Office Action Summary

10/662,751

GOSS ET AL.

DETAILED ACTION

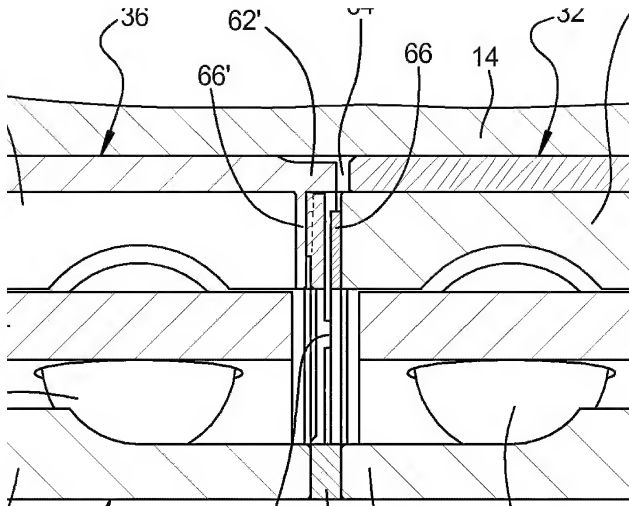
The drawings filed December 1, 2008 are objected to because the cross hatching in figure 6 is incorrect. The drawings filed December 1, 2008 will not be entered. Corrected drawing sheets in compliance with 37 CFR 1.121(d) are required in reply to the Office action to avoid abandonment of the application. Any amended replacement drawing sheet should include all of the figures appearing on the immediate prior version of the sheet, even if only one figure is being amended. The figure or figure number of an amended drawing should not be labeled as "amended." If a drawing figure is to be canceled, the appropriate figure must be removed from the replacement sheet, and where necessary, the remaining figures must be renumbered and appropriate changes made to the brief description of the several views of the drawings for consistency. Additional replacement sheets may be necessary to show the renumbering of the remaining figures. Each drawing sheet submitted after the filing date of an application must be labeled in the top margin as either "Replacement Sheet" or "New Sheet" pursuant to 37 CFR 1.121(d). If the changes are not accepted by the examiner, the applicant will be notified and informed of any required corrective action in the next Office action. The objection to the drawings will not be held in abeyance.

The following is an enlarged image showing the proper cross hatching which should be displayed in figure 6:
